CERTIFICATE OF APPROPRIATENESS

Property: 915 Harvard, Lot 9, Tract B, Block 230, Houston Heights Subdivision. The property includes a 2,476 square foot one and a half story residence with non-historic detached garage situated on a 6,600 square foot interior lot.

Proposal: Alteration – Replace Front Door and windows on noncontributing garage

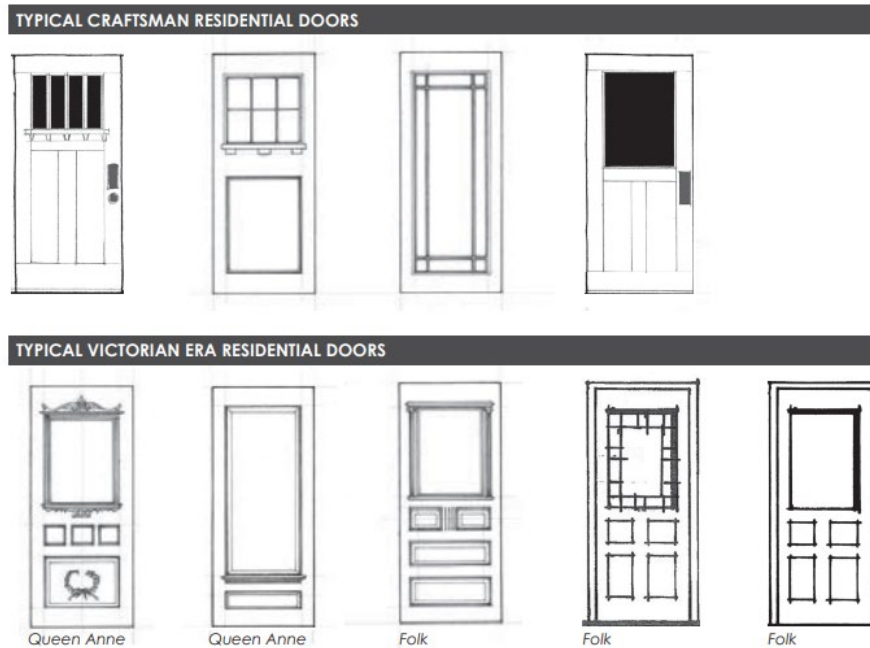
Style of proposed door references a more typical Victorian Era door as opposed to it's own style of Craftsman.

Recommendation: **Partial Approval:** Approve alterations on noncontributing garage (which qualify as administrative). Staff recommends denial on the removal of historic front door. The repair or replacement in kind of existing wood door would be recommended by staff, if owner consents.

RENDERING OF PROPOSED DOOR REPLACEMENT

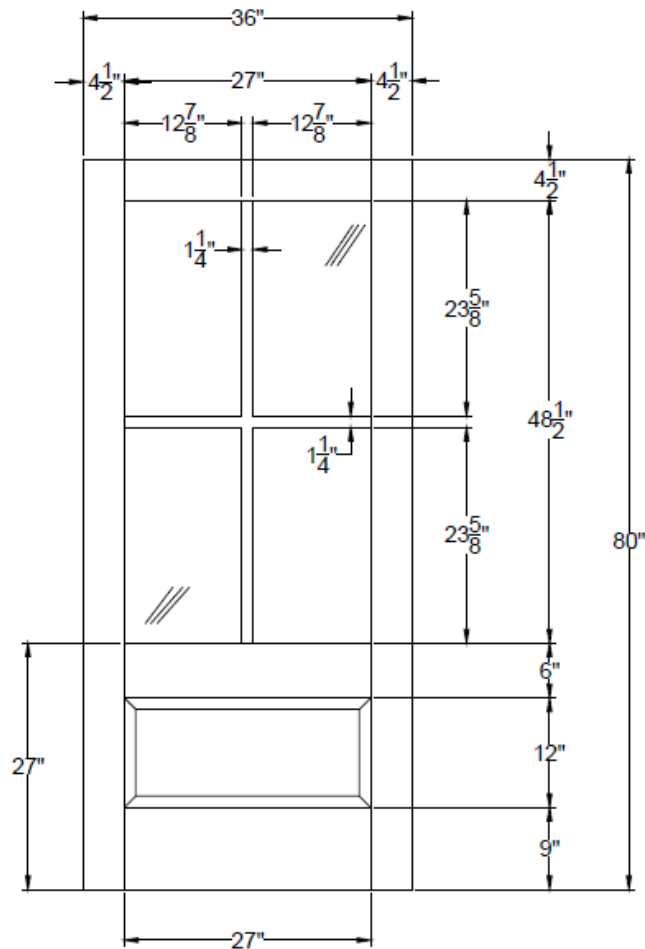
| <input type="checkbox"/> | <input checked="" type="checkbox"/> | <input type="checkbox"/> | (5) The proposed activity must maintain or replicate distinctive stylistic exterior features or examples of skilled craftsmanship that characterize the building, structure, object or site; <i>The proposed door does not replicate historic door but proposes a new design of another era.</i> |
| <input type="checkbox"/> | <input checked="" type="checkbox"/> | <input type="checkbox"/> | (6) New materials to be used for any exterior feature excluding what is visible from public alleys must be visually compatible with, but not necessarily the same as, the materials being replaced in form, design, texture, dimension and scale; <i>The proposed door does not replicate historic door but proposes a new design of another era.</i> |
| <input type="checkbox"/> | <input checked="" type="checkbox"/> | <input type="checkbox"/> | (7) The proposed replacement of exterior features, if any, should be based on an accurate duplication of features, substantiated by available historical, physical or pictorial evidence, where that evidence is available, rather than on conjectural designs or the availability of different architectural elements from other structures; <i>The proposed door does not replicate historic door but proposes a new design of another era.</i> |
| <input type="checkbox"/> | <input checked="" type="checkbox"/> | <input type="checkbox"/> | (9) The proposed design for any exterior alterations or addition must not destroy significant historical, architectural, archaeological or cultural material, including but not limited to siding, windows, doors and porch elements; <i>Proposed door removes existing historic door.</i> |
